# SERVICE NEWS

**TX81Z**

BULLETIN NO.: E-399

## ROM Updated

## Power Transformer Modified

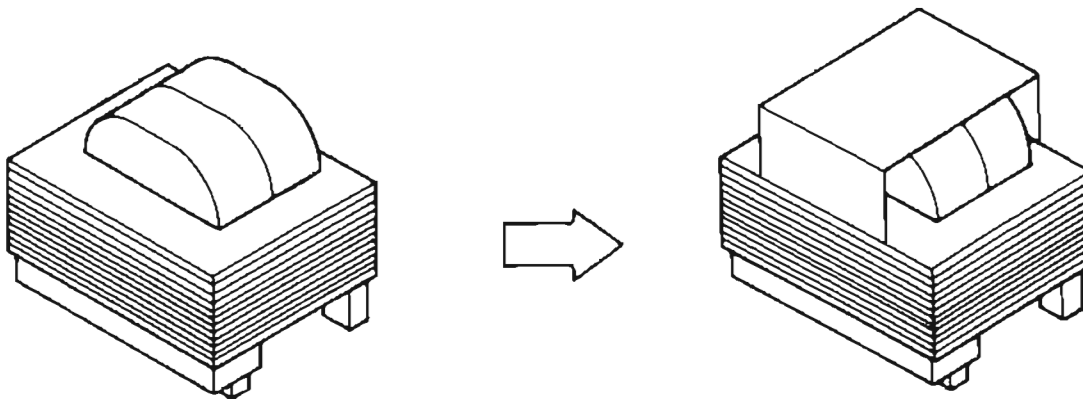
**Modification:** A metal cover has been added to the transformer to prevent vibration due to leak magnetic flux.

Parts:	Description	Part No.	Remarks
	Power Transformer	XB358002	U, C
	Power Transformer	XB359002	H, D, A
